PLANNING REPORT #34-97

**JOKERS FAMILY ENTERTAINMENT CENTER
510 WARREN AVENUE**

SITE PLAN REVISIONS

**Portland Planning Board
Portland, Maine**

C-9

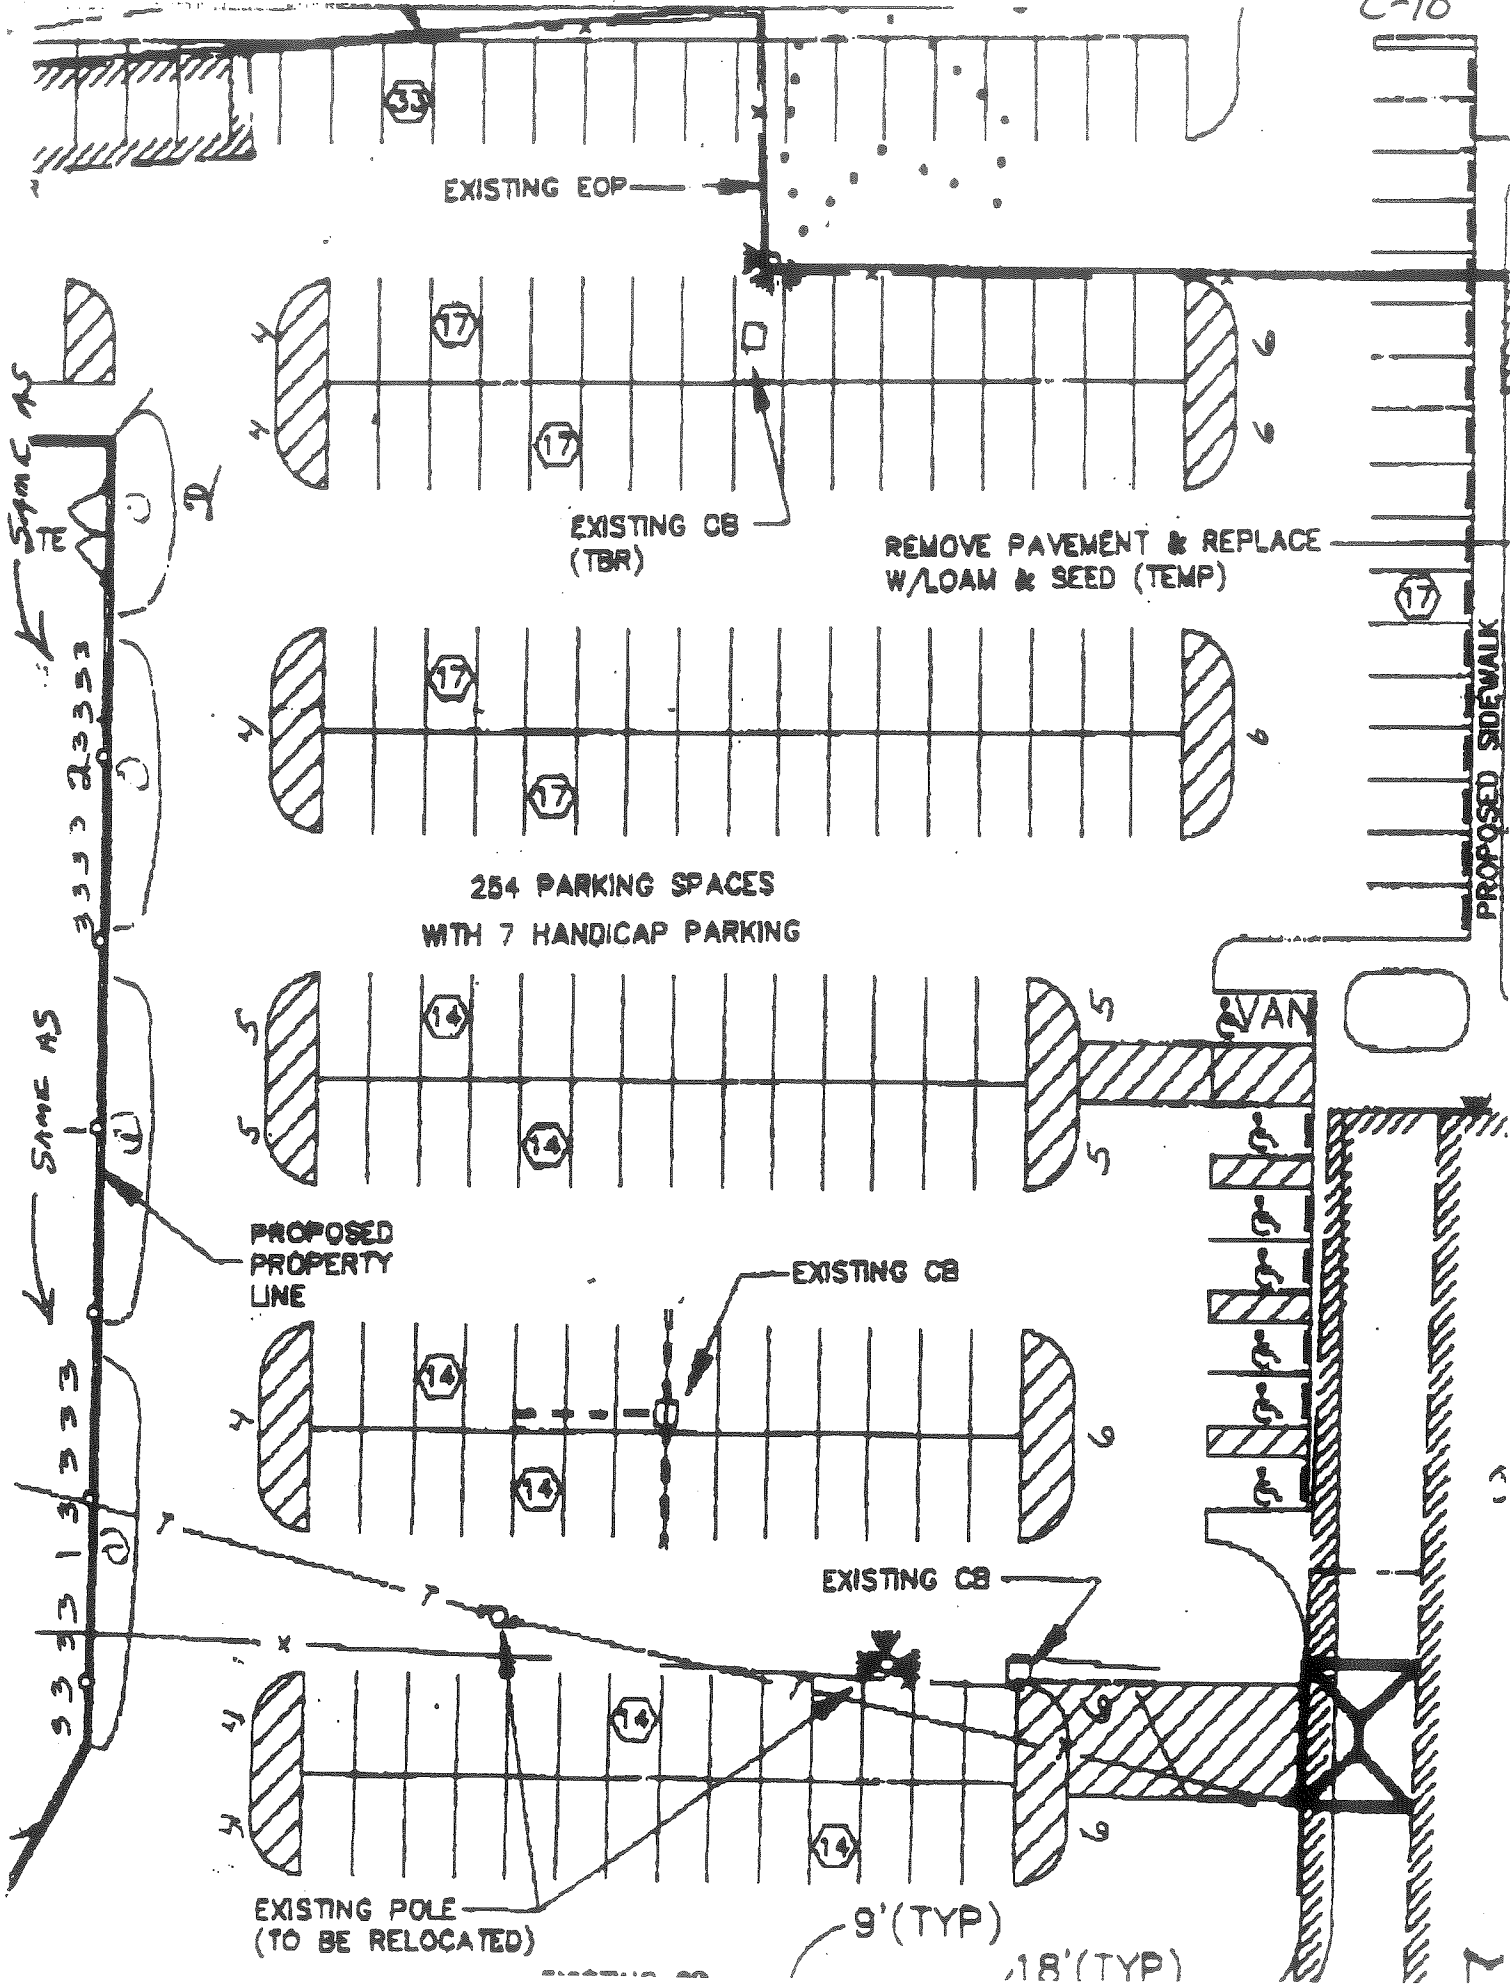
ELIMINATE 3 TILIA CORDATA IN LONG ISLAND DUE TO THE PLANTING BED BEING NARROWER THAN THE TREE BALL.

ADD 20 POTENTILLA TO THE PARKING ISLAND TO SUPLIMENT THE COLOR OF THE PLANTING.

THE LOCATIONS OF THE ISLANDS WHERE EACH TREE TYPE IS PLANTED IS MARKED (OFF SET) ON THE PLAN. WHEN THERE IS ANY VARIATION A NEW SKETCH OR MARKED SAME AS AND DREW AN ARROW TO ORIGINAL REFERENCE. SEE SKETCH PAGE.

Mini-Golf Planting Schematic
 Jokers Two Family Fun and Games
 510 WARREN AVENUE
 PORTLAND, ME

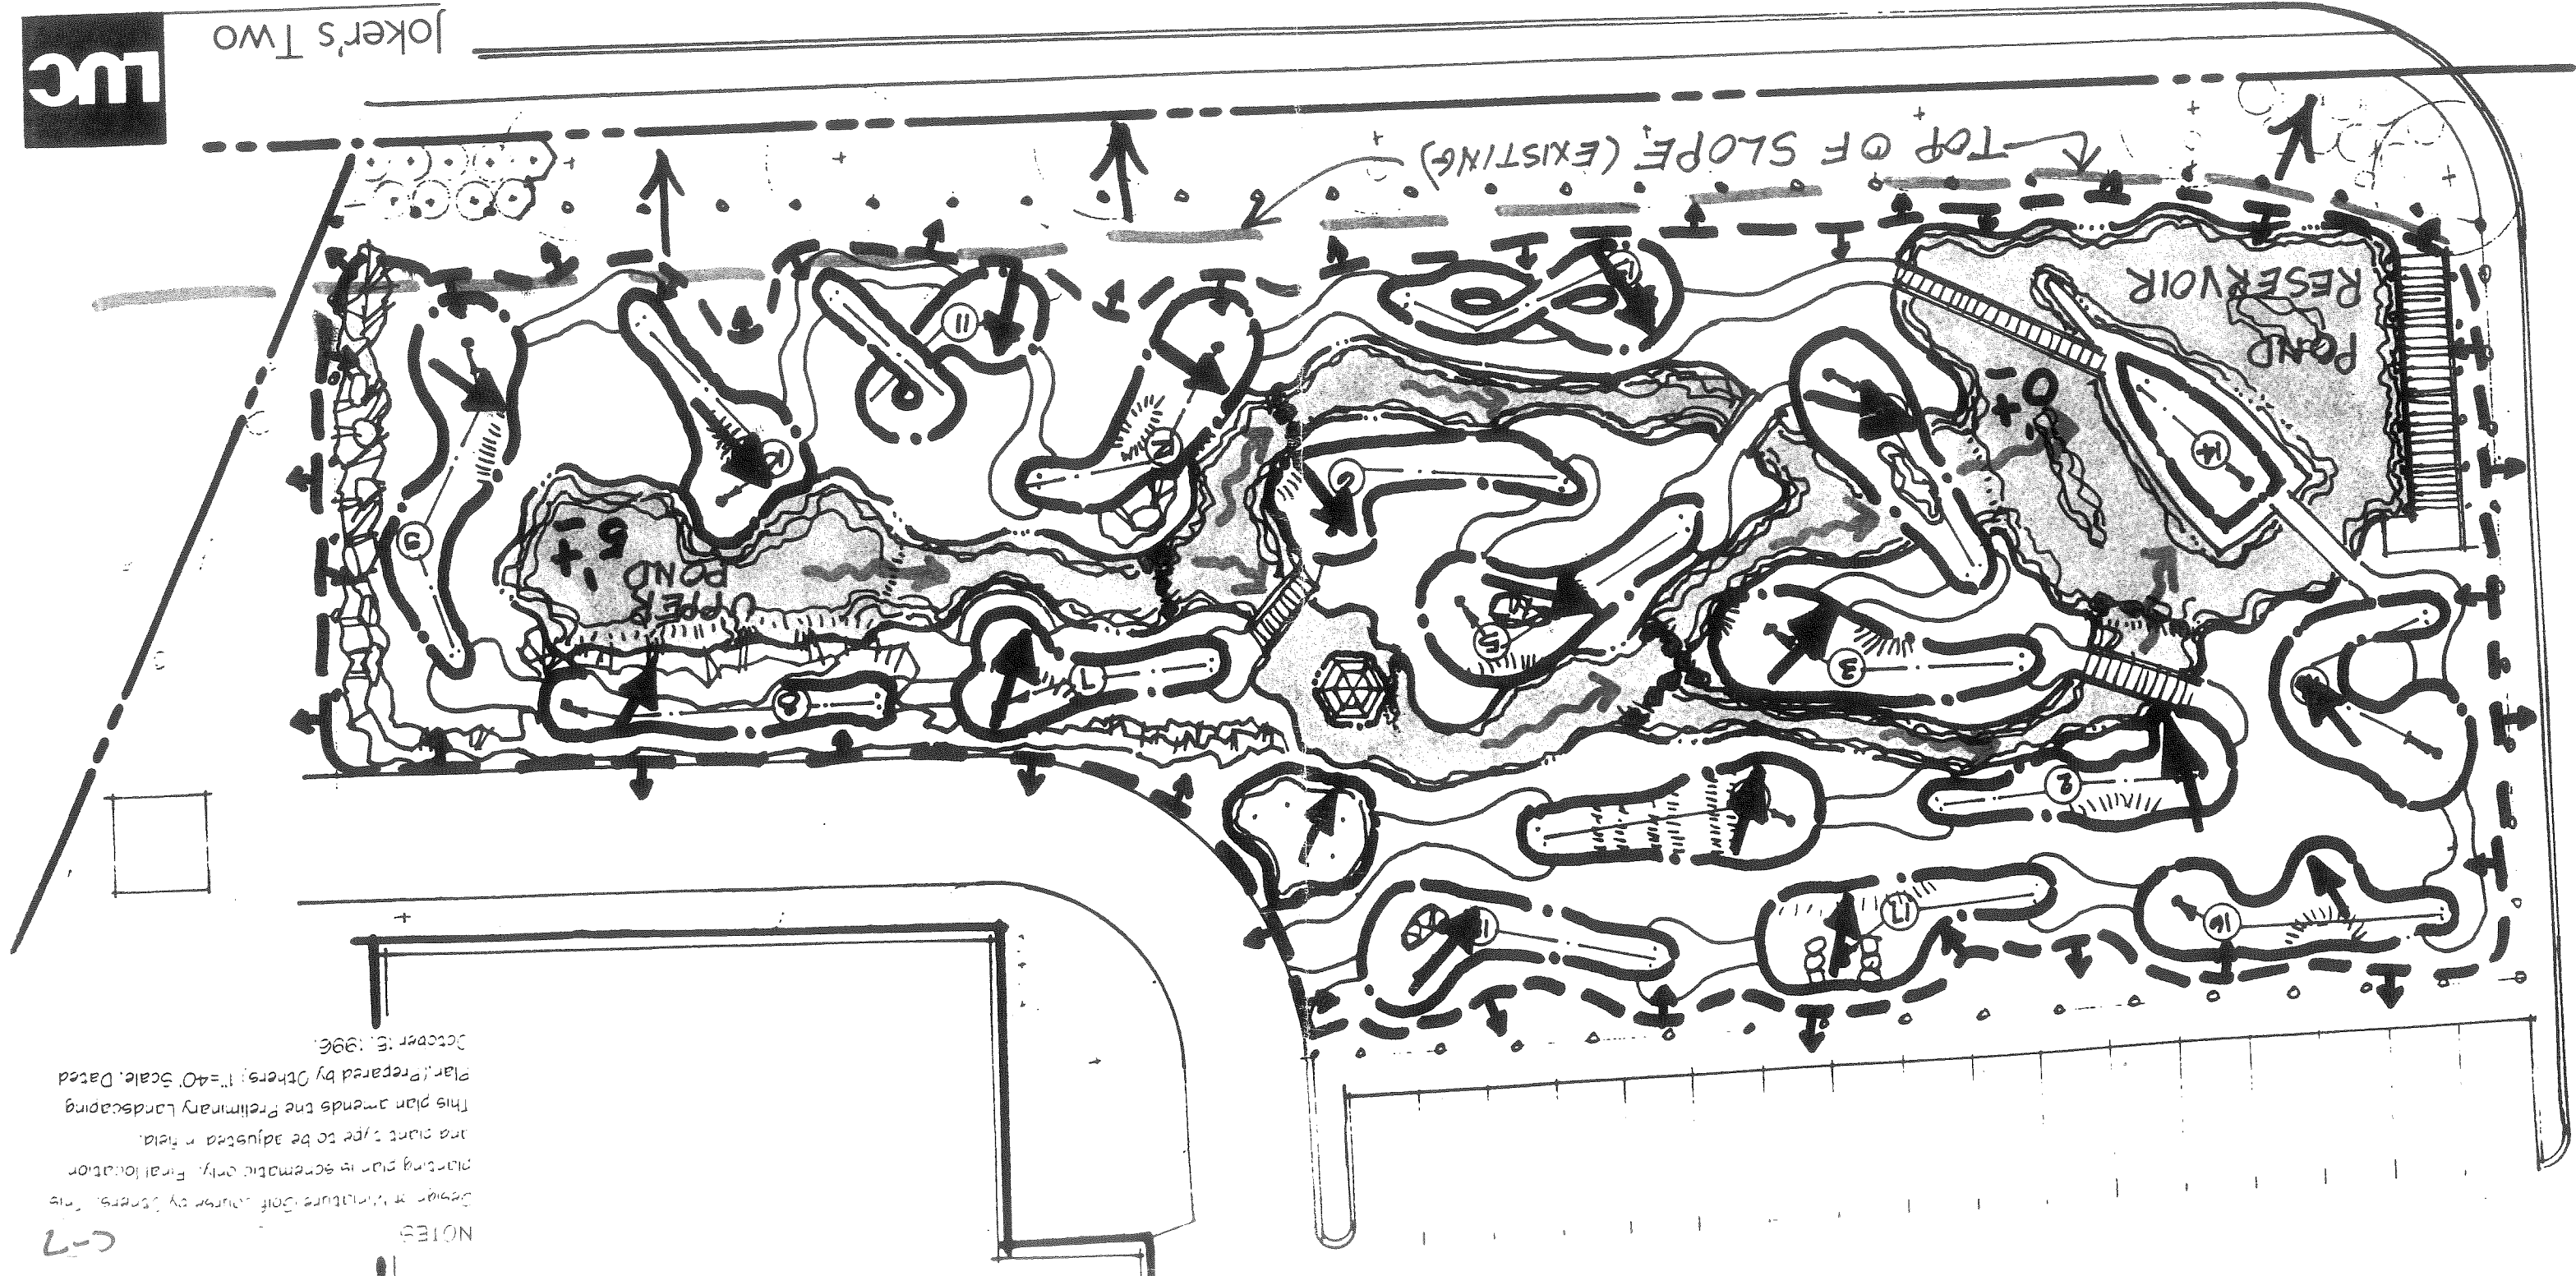
The plan indicates that a light fixture and pole (same type as in the parking lot) will be installed in the golf course although the location is not shown on the plan. Additional lighting within the ponds and waterways as well as the ship and lighthouse will be provided.

The original landscaping plan indicated 8 street trees along Warren Avenue. The applicant proposes to plant 4 trees instead with the remaining trees planted within the golf course. These trees will be supplemented by other plantings planned for the golf course.

- i. That the location and specifications of exterior lighting for the mini golf course be submitted for planning staff review and approval.

LANDSCAPING PLAN
 JOCKERS TWO, INC.
 510 WARREN AVENUE
 PORTLAND, MAINE
 SCALE: 1" = 40' NOVEMBER 5, 1996

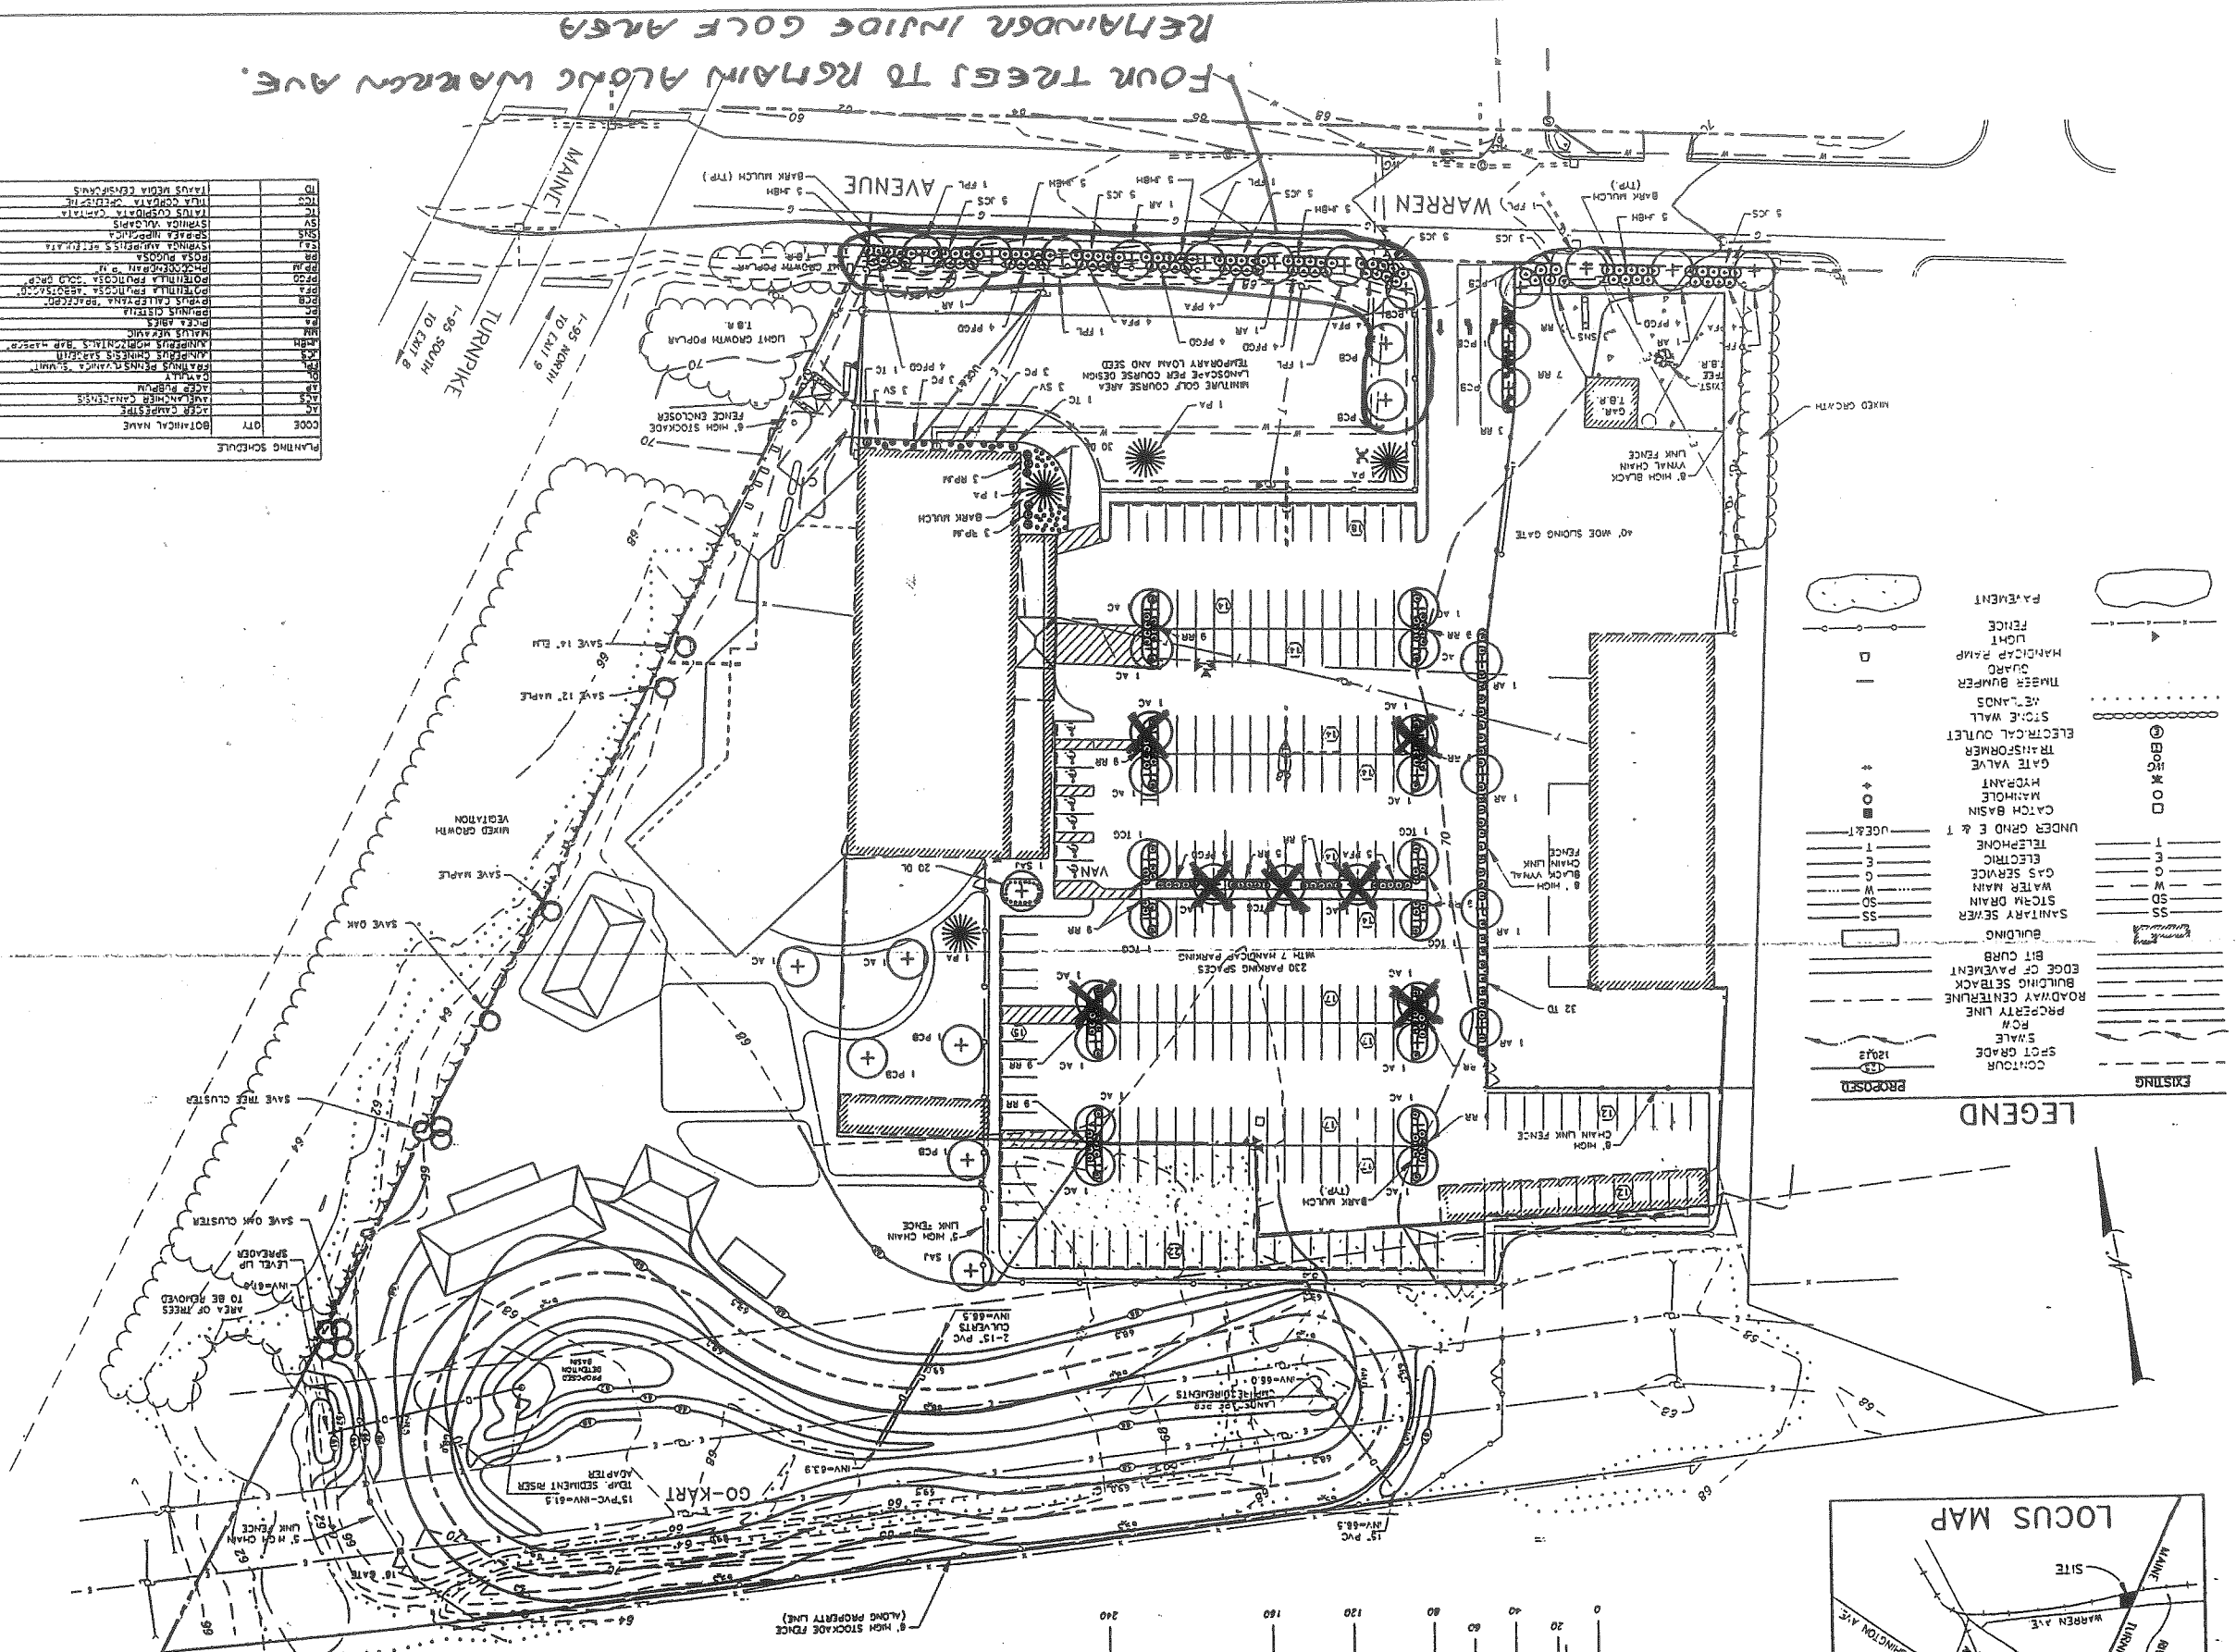
The applicant is proposing to reduce the amount of landscaping within the landscaped islands of the existing parking lot. The original plan showed 2 trees at the ends of each parking aisle. The applicant proposes that two of the parking aisles (or 4 islands) will have one tree in each island instead of two. See Attachment D. In addition 3 trees will be eliminated from an extended island in the middle of the parking lot. Landscaping at this location helps to break up the large expanse of black top and to control cut through traffic. Several trees along the right hand side of the driveway will also be eliminated.

TREES TO BE ELIMINATED

With respect to the landscaping changes, the substitution of understory materials within the islands is acceptable. We are very reluctant to approve the remaining revisions on the plan since the Planning Board will be reviewing the site plan at a later date. Nonetheless, we would feel comfortable reducing the number of street trees along Warren Avenue (westerly side of the driveway) from eight (8) to six (6) trees.
